# UNITED STATES PATENT AND TRADEMARK OFFICE

10/577,436

<b>Office Action Summary</b>	<b>Application No.</b> 10/577,436	<b>Applicant(s)</b> GESKES ET AL.	
	<b>Examiner</b> Allen J. Flanigan	<b>Art Unit</b> 3744

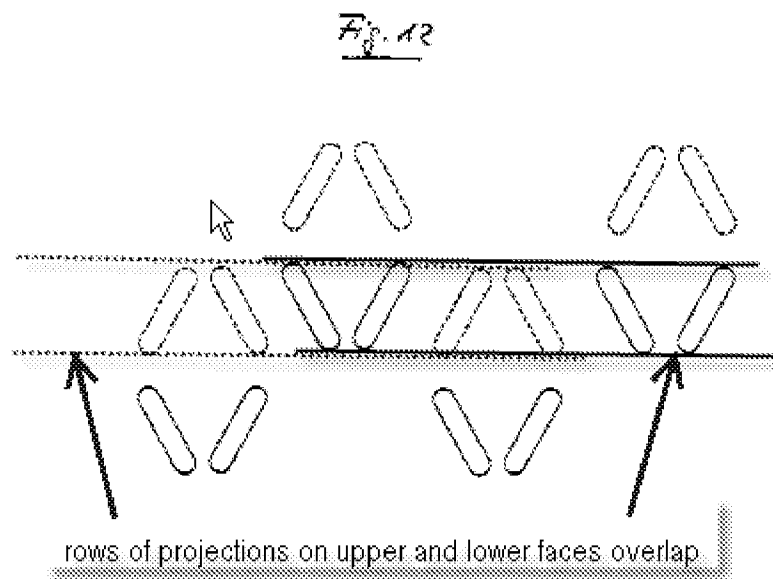
Claims 1-3, 19, 21, 23, 29, 30, 39, 40, 43, 44, 46, and 48 are rejected under 35 U.S.C. 102(b) as being anticipated by Pantow et al.

Pantow et al. show an embodiment (Fig. 12) that reads on the above claims, in that rows of mirror image flow disrupting projections are provided in oppositely facing walls of a flat heat exchange tube such that the rows overlap:

All of the remaining limitations of the above dependent claims are also found in Pantow et al. Regarding claim 44, virtually any fluid can potentially flow within and without the tubes of Pantow et al.
